Date: April 10, 2008
To: Design Review Board
From: Tony Leavitt, Associate Planner
Subject: Juanita Townhomes (DRC06-00004) Post Approval Review

JUANITA TOWNHOMES DESIGN RESPONSE CONFERENCE NOTICE OF APPROVAL

PERMIT NO. DRC06-00004

PROPOSED SITE PLAN

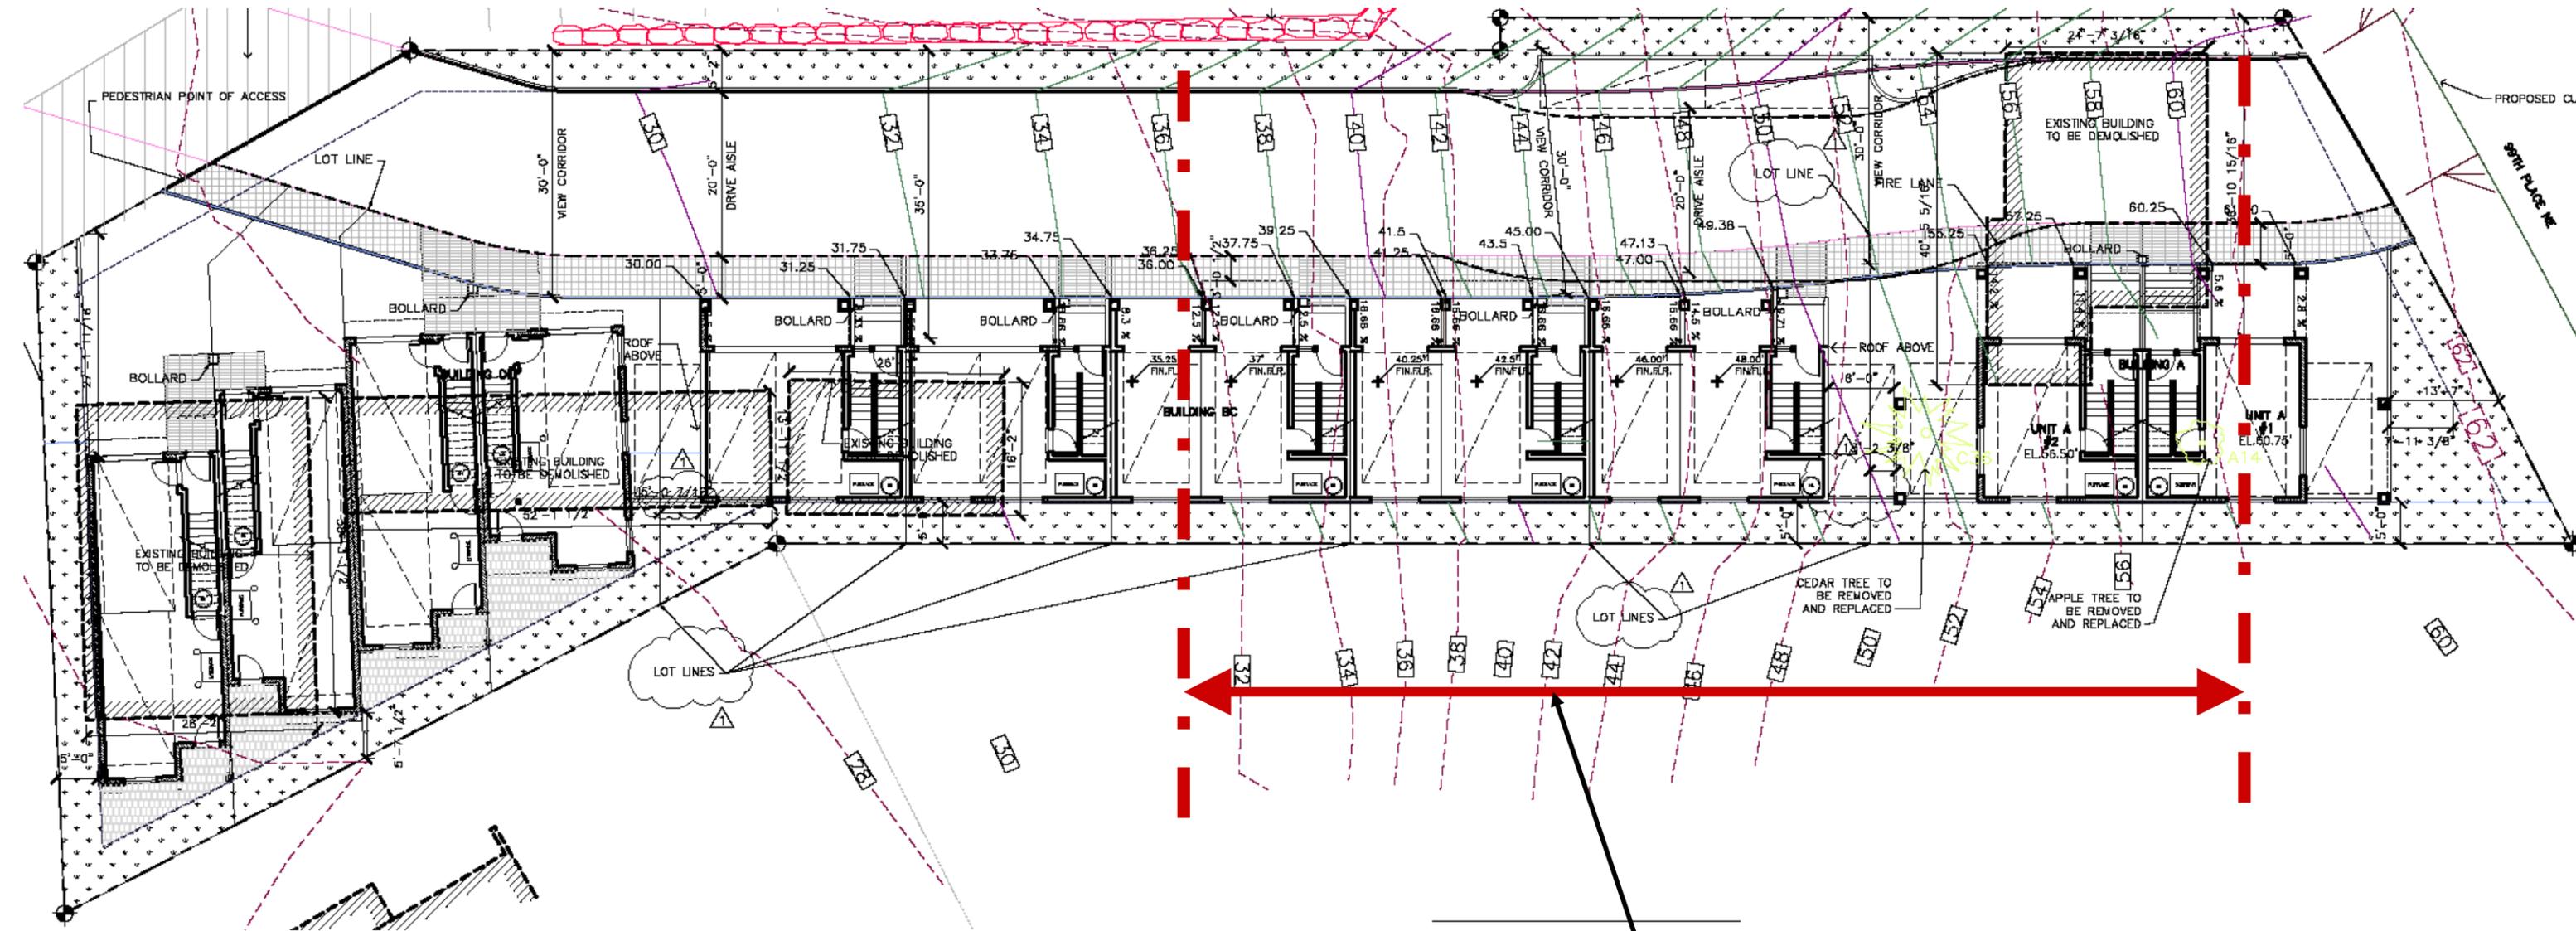
The applicant submitted a revised plan set to address the post approval requirements (see Attachment 3). In order to address the shifting of Building AA and not lose a required parking stall, the applicant added a parking stall between Building AA and the 99th Place right-of-way. Additionally, the applicant is proposing new concrete bollards along the access tract/driveway.

In addition to addressing these requirements, the applicant made some changes to the approved site plan. These changes were necessitated by a surveying error that was discovered after approval by the DRB. The site plan changes include:

- Relocating Buildings BC and DE to the east to meet setback requirements from the west property line (that was incorrectly surveyed).
- Two parking stalls (one stall between Buildings BC and DE and one stall to the west of Building AA) were eliminated as a result of having to relocate the buildings.
- The addition of two parallel parking stalls along the northern edge of the access tract/driveway to compensate for the loss of the two parking stalls mentioned above.

- Are the proposed bollards comparable to the approved bollards?
- Does the location of the parking stall between Building AA and the 99th Place right-of-way work? Does the parking stall need to be screened from the adjoining right-of-way with additional landscaping or fencing?
- Are there any concerns with the proposed location of the parallel parking stalls along the northern edge of the access tract/driveway?
- Is the final landscaping plan adequate?
